State of New Mexico  
Energy, Minerals and Natural Resources

WELL API NO. 30-025-00286 ✓
5. Indicate Type of Lease STATE <input checked="" type="checkbox"/> FEE <input type="checkbox"/>
6. State Oil & Gas Lease No.
7. Lease Name or Unit Agreement Name Rock Queen Unit ✓
8. Well Number 2 ✓
9. OGRID Number 247128 ✓
10. Pool name or Wildcat Caprock; Queen

SUNDRY NOTICES AND REPORTS ON WELLS  
(DO NOT USE THIS FORM FOR PROPOSALS TO DRILL OR TO DEEPEN OR PLUG BACK TO A DIFFERENT RESERVOIR. USE "APPLICATION FOR PERMIT" (FORM C-101) FOR SUCH PROPOSALS.)

To convert to monitor well as per Order No. R-1541-B

Proposed Monitor Well

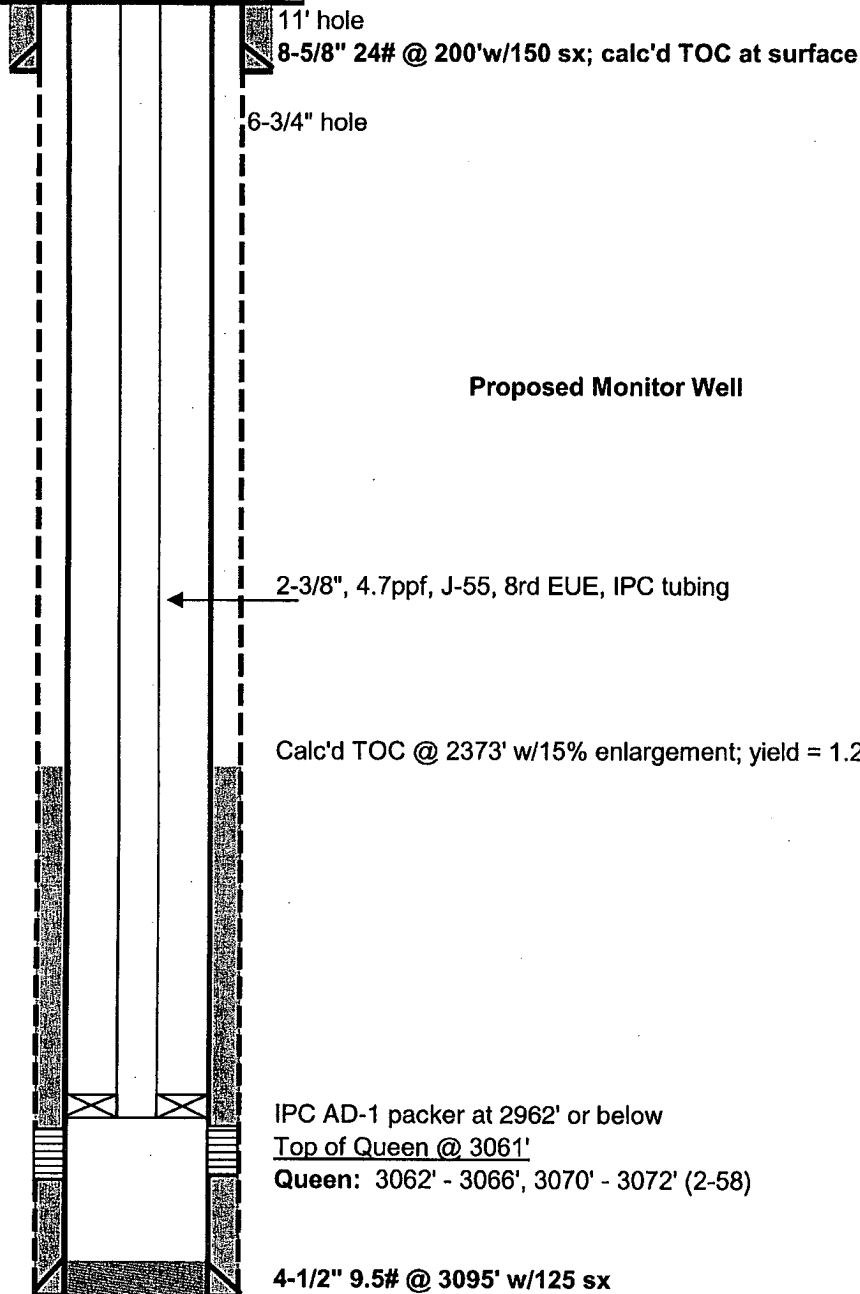
Per Underground Injection Control Program Manual  
11.6 C Packer shall be set within or less than 100  
feet of the uppermost injection perfs or open hole.

Condition of Approval: Notify OCD Hobbs  
office 24 hours prior of running MIT Test & Chart

IPC AD-1 packer at 2962' or below  
Top of Queen @ 3061'  
Queen: 3062' - 3066', 3070' - 3072' (2-58)
